Maura J. Rossman, M.D., Health Officer**APPLICATION****FOR PERCOLATION TESTING AND SITE EVALUATION****PROPERTY LOCATION**

Percolation Test Report; 3255 Roscommon Drive,

RE: OSDS Plan
3255 Roscommon Drive

PERC CERTIFICATION PLAN
3255 ROSCOMMON DRIVE
LOT 9 ROSCOMMON ESTATES
PLAT #8262 TITLE DEED: 18038/44
TAX MAP 22, GRID 1, PARCEL 549
3rd ELECTION DISTRICT, HOWARD COUNTY, MD.
SCALE: 1" = 50' DATE: 5/28/2018 REV. 7/23/2018
PURPOSE: TO EXPAND HOUSE TO AN ASSISTED LIVING FACILITY WITH 8 BEDROOMS

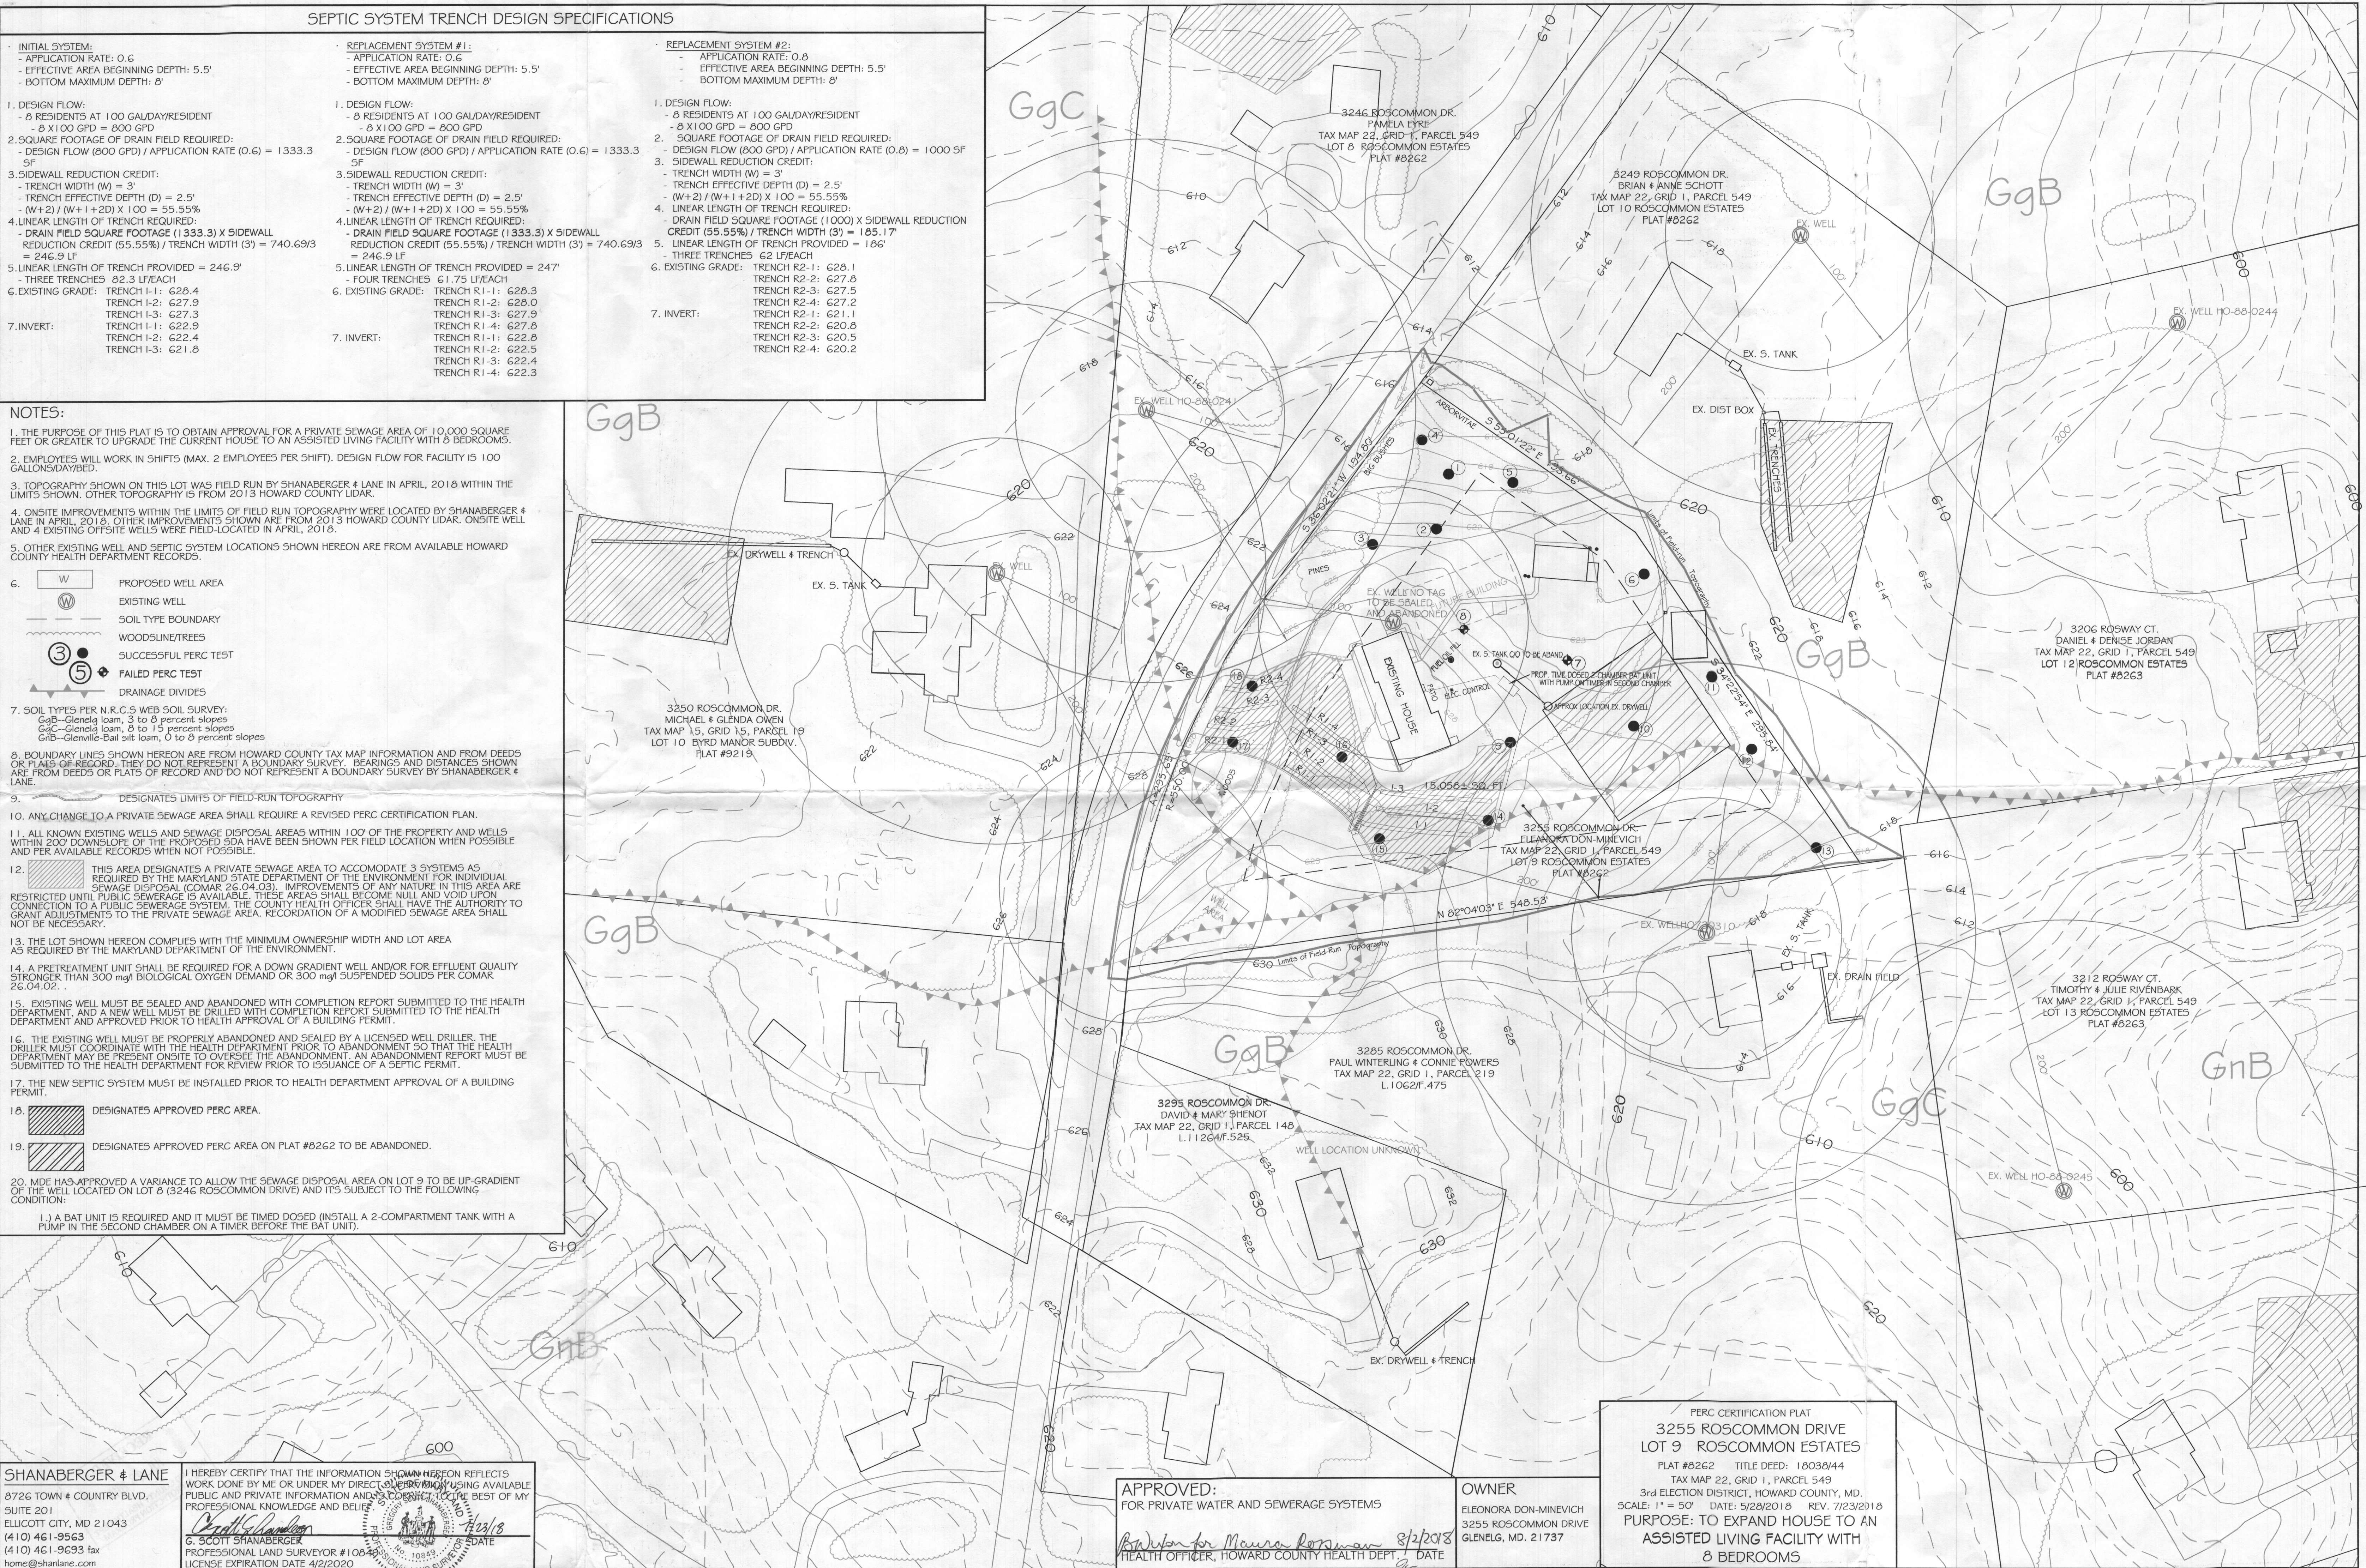
Hi Steve. Sorry I forgot to go over this with you when you were here. This property has a funky shaped sewage disposal area. They are converting a house to a small assisted living facility. As you can see on the plan, the contour is a little tricky, but by my assessment the initial system is not upgrade of any neighboring wells, but the 2nd replacement and possible a portion of the first replacement is upgrade of the one neighboring well.

MDE has approved a variance to allow the sewage disposal area to be up-gradient of the neighboring well and subject to the following condition:

1.) The BAT unit must be timed dosed (Install a 2-compartment tank with a pump in the second chamber on a timer before the BAT unit).

Good morning. MDE has approved the variance request. Please add the following note to the plan.
